Migrating from STR91xF to STR91xFA

This document describes at the system level the feature enhancements and silicon fixes incorporated in the new STR91xFA devices, compared to the original STR91xF devices.

Figure 1. Memory accelerator

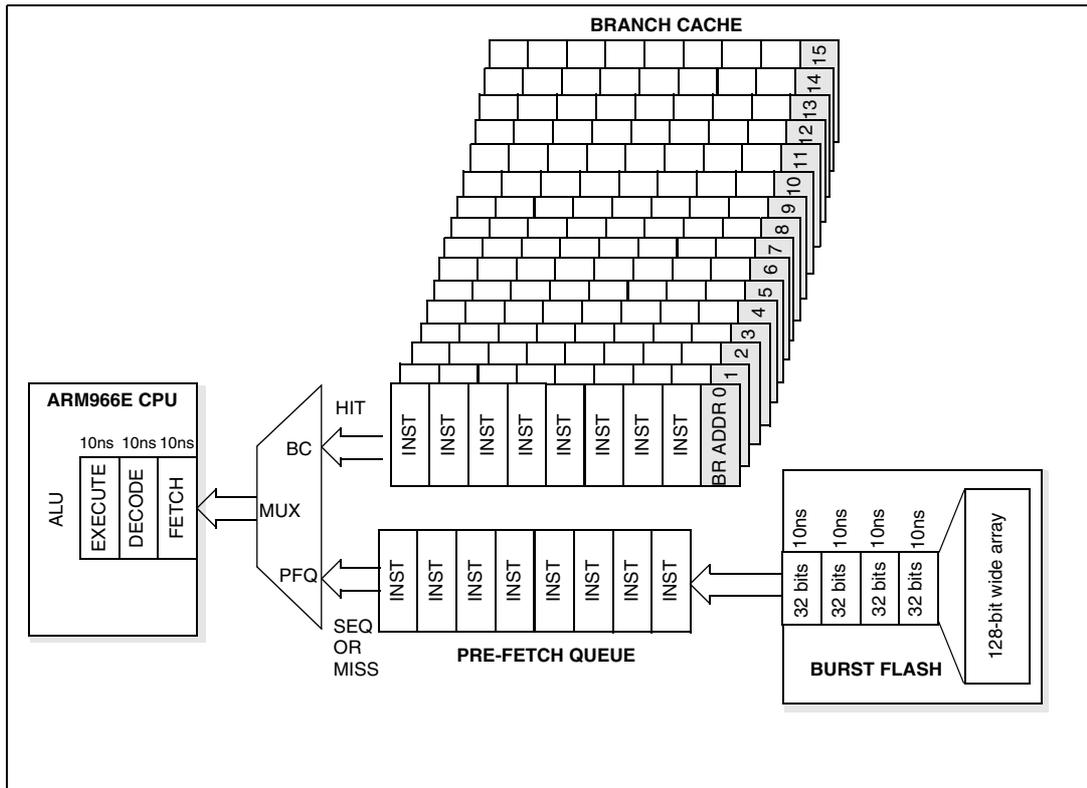
In STR91xFA, the number and size of branch cache entries was increased from five entries with four words each to 16 entries with 8 words each. The 16 entries are partitioned into 15 general purpose entries plus one entry dedicated to the VIC. The branch cache serves to accelerate instruction fetching from the burst-mode flash memory in looping code.

Impact: Performance enhancement. Fewer wait states will be incurred in response to program branches taken repeatedly. Aside from the performance improvement, the change is completely transparent to both systems and application software.

In STR91xF, the FMI_CR register bit 0 is used to define the PFQ FIFO size (4 or 8 words). In STR91xFA this bit becomes a "don't care" bit. The PFQ FIFO size is always powered up as 8 words. The change in FIFO word size will have no impact on your system operation.
